Thank you for helping me to submit a revised draft of my manuscript titled **Characteristics of debris flows recorded in the Shenmu area of central Taiwan between 2004 and 2021** to *Natural Hazards and Earth System Sciences*. I appreciate the time and effort that you have dedicated to providing your valuable feedback on my manuscript. I am grateful to the reviewer's insightful comments on my paper. I have been able to incorporate changes to reflect most of the suggestions provided by the reviewers. I have highlighted the changes within the manuscript. After the revision, I believe that this study and its outcomes fulfil the scope of journal.

Comments from Reviewer RC2

Fig. 1.

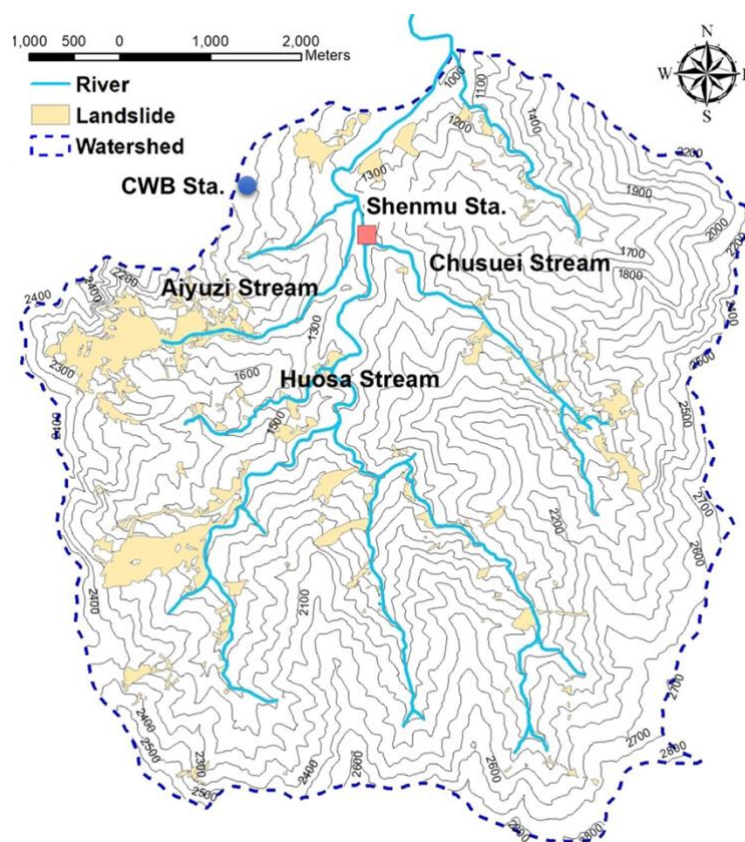
- **Comment 3:** *Line 42-45: two important rainfall data resources were proposed here. Please address them in Fig.1 or 2.*

Response: Thank you for your suggestion. The rainfall stations are added and marked on Figure 1.
